# PACKARD MOTOR CAR COMPANY

August 15, 1928.

Subject: Carburetor Air Cleaner.

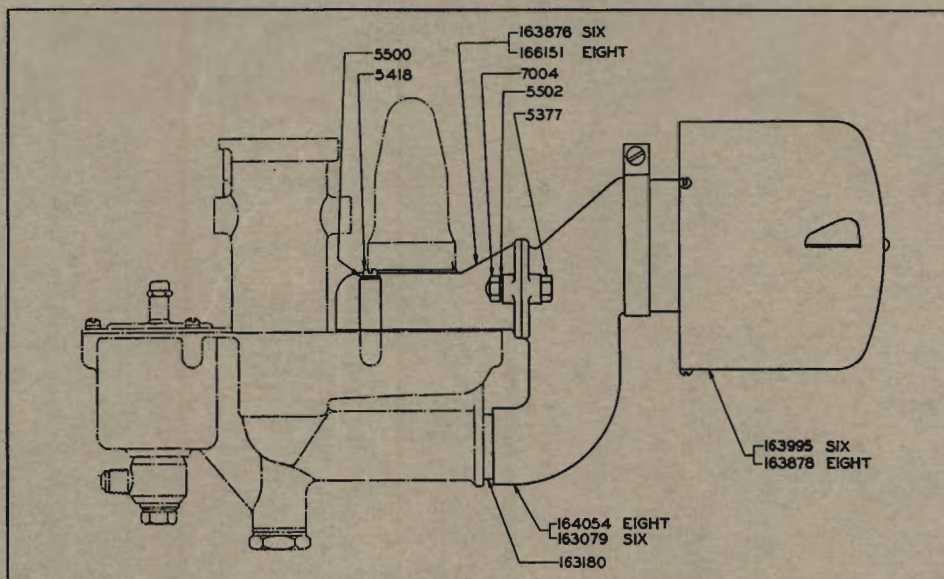
When a car is operated under such conditions that a considerable amount of road dust is encountered an air cleaner will improve the condition of the crankcase oil and will increase the life of the cylinders, pistons and rings. The illustration shows the equipment which has been developed for this purpose.

The manner of attachment is clearly illustrated. The old air valve is mounted in the new seat and at the bottom connection a steel ferrule is used to make a slip joint between the carburetor body and the air cleaner casting.
